ENGINEERING CHANGE NOTICE NO.

05360

DWG TITLE: CUTTER SUB ASSY

REASON: REVISED DIMENSIONS

SHEET 1, ZONE A6 IS:

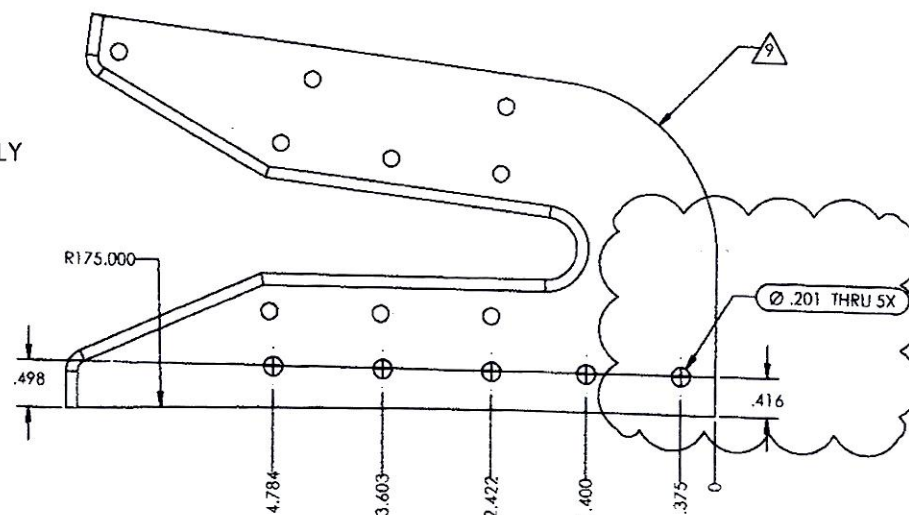
REASON: REVISED NOTES

IS

- 1 MATERIAL: ALUMINUM 7075-T651 PER AMS-QQ-A-250/12
- 2 FINISH IAW MPP-172 SECTION 2.1, 3.3 & 4.3.
- 3 MATERIAL: AISI A2 TOOL STEEL
CONDITION: ANNEALED
POST PROCESS: HEAT TREAT TO 58-62 Rc ROCKWELL HARDNESS
- 4 FINISH: PRIME IAW MPP-172 SECTION 3.3; 1-2 MIL MAX
5. DEBURR AND BREAK ALL SHARP EDGES EXCEPT WHERE OTHERWISE NOTED
6. IDENTIFY IAW MPP-120
- 7 APPLY F/N 5 AS REQUIRED TO ALL FAYING SURFACES OF F/N 2 UPON ASSEMBLY
- 8 CUTTING EDGE INTENDED TO BE SHARP, DO NOT BREAK SHARP EDGE
- 9 ALL DIMENSIONS NOT SPECIFIED ARE CONTROLLED BY 646.9710.

SHEET 7, ZONE C5 IS:

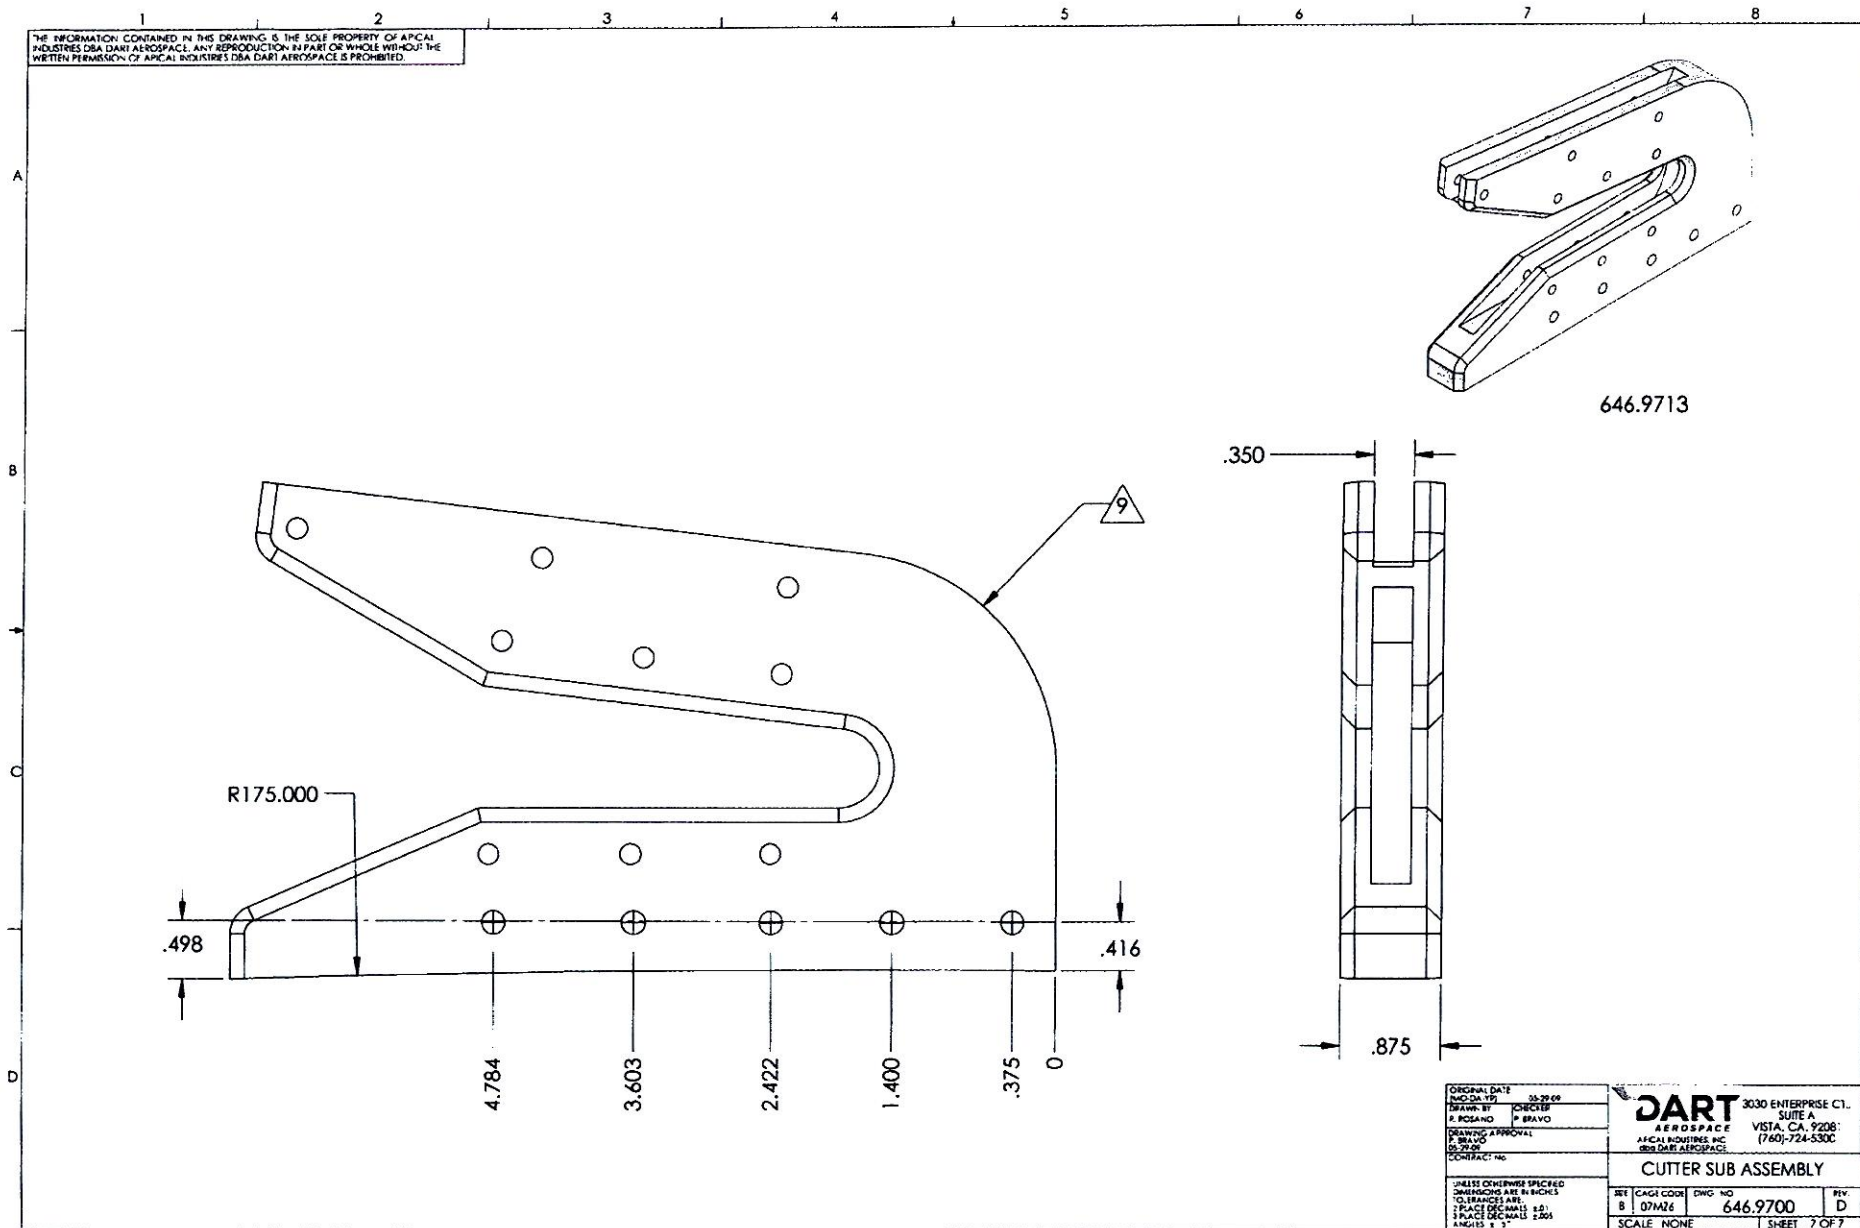
SHEET 7, ZONE C3 IS:
